CITY OF WEST DES MOINES
STAFF REPORT COMMUNICATION

ITEM: Woodland Estates Plat 1, NE corner of S. Kingswood Court and Stagecoach Drive – Approve a Preliminary Plat to create 22 lots for Single Family Residential development, one outlot for future development and one street lot – Silo 9 LLC – PP-005161-2021

Resolution: Approval of Preliminary Plat

TYPICAL SECTION - 61' B-B PCC ROADWAY - STAGECOACH DRIVE
NOT TO SCALE

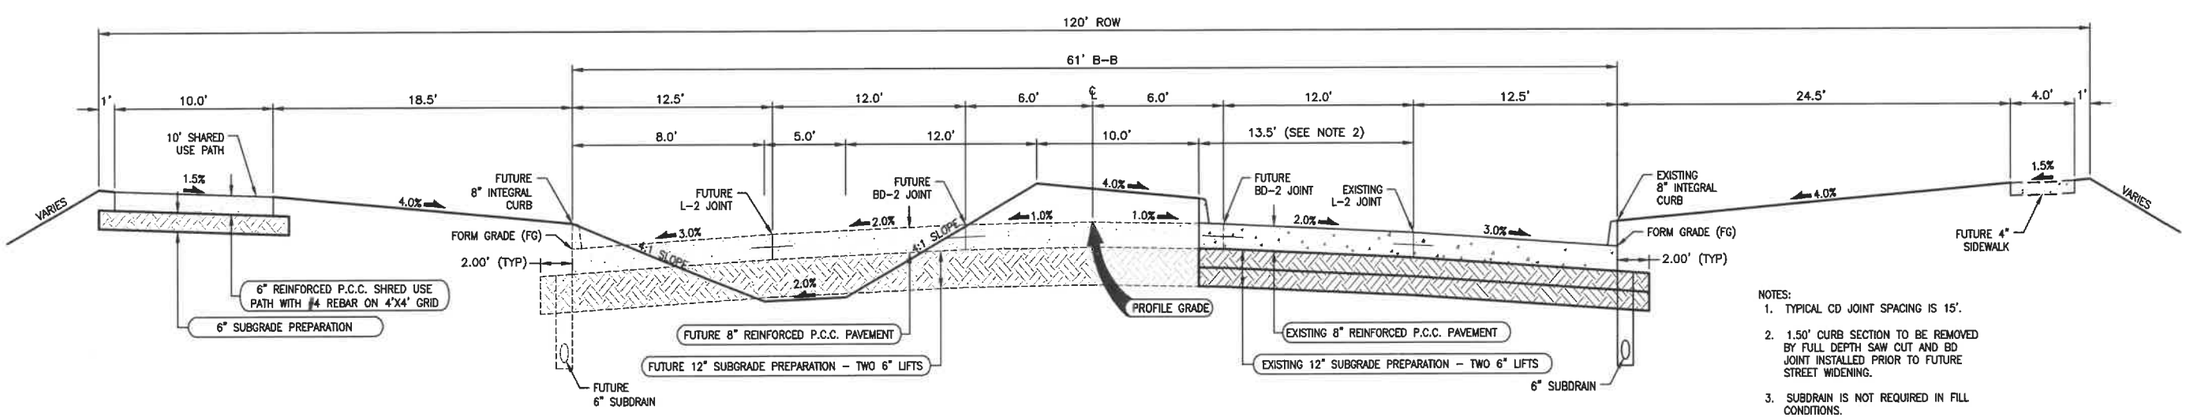
- *Stagecoach Trail:* A typical ten foot (10') Public Trail is planned for along the north side of Stagecoach Drive but will not be installed until such time that the grading for the widening of Stagecoach Drive is complete. The developer is only responsible for four feet (4'), the typical sidewalk width. A 60/40 Trail Agreement will be executed in conjunction with the Final Plat.

- *Traffic Impact Study Findings:* A new study with the additional lot was not done as there is no concerns with traffic generation for the extra lot. The original study identified that the site is expected to generate less traffic than previously analyzed. The study indicates that S 95th Street should be a 2-lane roadway widening to 3-lanes for left turns at Stagecoach Drive (and ultimately at Mills Civic Parkway and possible Cascade Avenue). An additional lane of Stagecoach Drive adjacent to the development will be needed in the future.

- *Developer Responsibilities:* The developer is responsible for all typical public infrastructure improvements including public streets, public storm and sanitary sewer, sidewalks, and streetlights. Additionally, as noted in the Traffic Impact Study section, an additional lane of Stagecoach Drive, including all appurtenances necessary, will be required in the future. The City Attorney's Office is preparing a Development Agreement detailing this responsibility of the developer. Staff recommends that this agreement be executed prior to approval of the associated Final Plat.

1. The Applicant acknowledging the responsibility for the future construction of an additional lane of Stagecoach Drive. The applicant agreeing that their execution of the associated Development Agreement shall be provided to the City prior to City Council consideration of the associated final plat.

6. The City Council deferring the installation of the ten foot (10') trail along the north side of Stagecoach Drive until such time that Stagecoach Drive is widened or the trail is necessary to make a connection to trails along Stagecoach Drive immediately to the east and west.

WOODLAND ESTATES PLAT 1
LANDSCAPE PLAN
WEST DES MOINES, IOWA

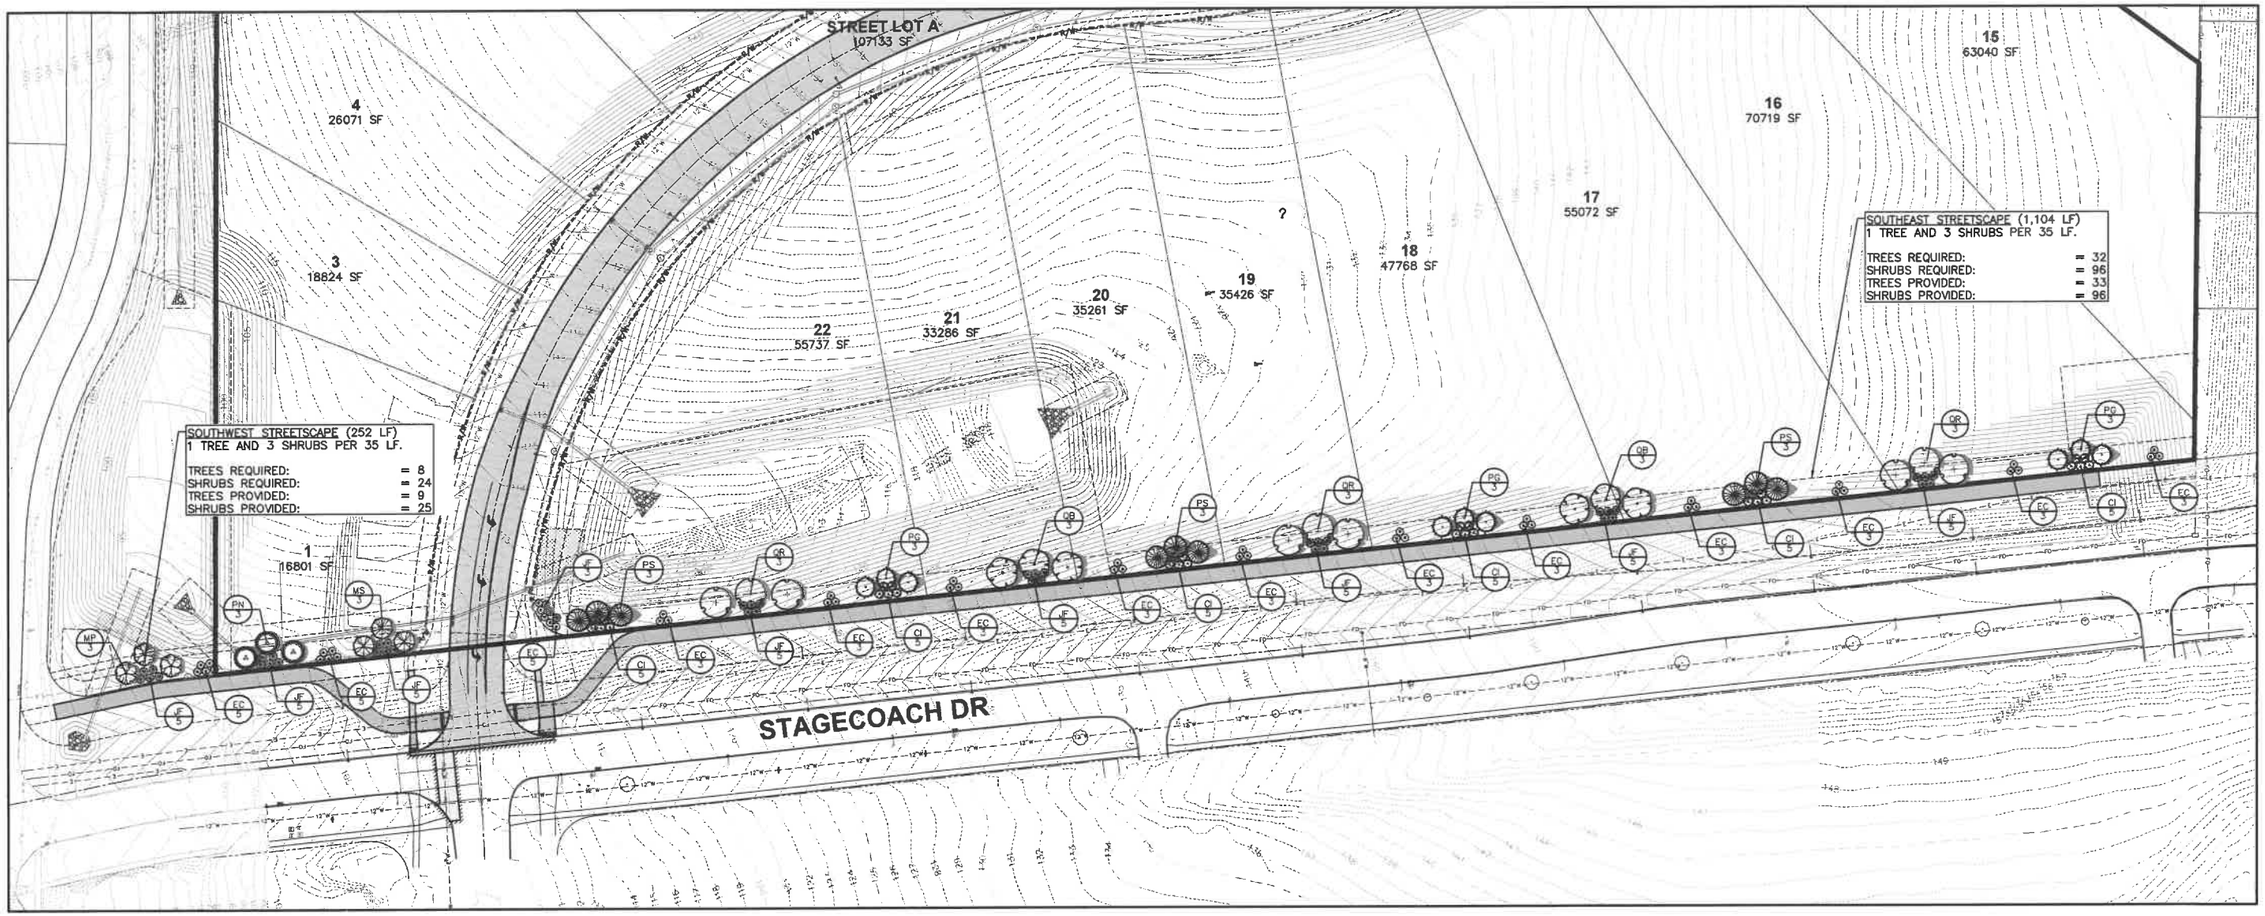
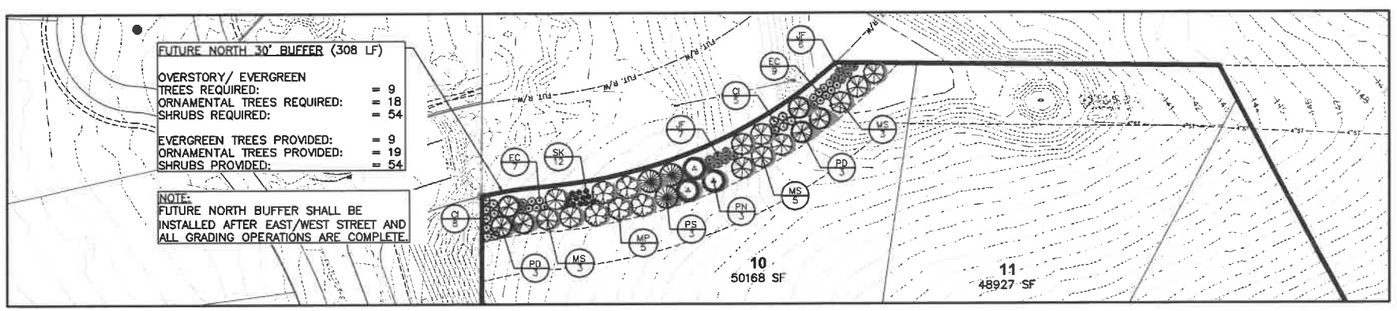
- *Stagecoach Streetscape:* Although double-frontage lots, due to the depth of the lots and presence of existing trees, the traditional thirty-foot (30') buffer along the rear lot line (Stagecoach Drive) is waived in favor of continuing the streetscape plantings done as part of the adjoining plats within the Tallyn's Reach (fka Michael's Landing; nka Woodland Hills) development.

- *Lot 10 Buffer:* A future roadway extension out of the adjoining Majestic Oaks Subdivision is intended that would border the rear lot line of Lot 10 thus making it a double frontage lot. A minimum thirty-foot (30') landscape buffer is required; however, so as to not disturb the buffer plantings, installation of the buffer is deferred until such time that the roadway extension is constructed.

3. The City Council granting allowance of the placement of Public Utility Easements (PUEs) in the front yard of all lots.
4. The City Council accepting the continuation of the Stagecoach Drive Streetscape Planting Plan in lieu of a thirty-foot (30') buffer along the rear (south) lot line of lots 15-22 and the side (south) lot line of lot 1.

5. The City Council granting a deferral of the installation of the buffer along the rear lot line of Lot 10 until such time that the adjacent future street is graded and any construction that may affect the survivability of the buffer plantings is complete.
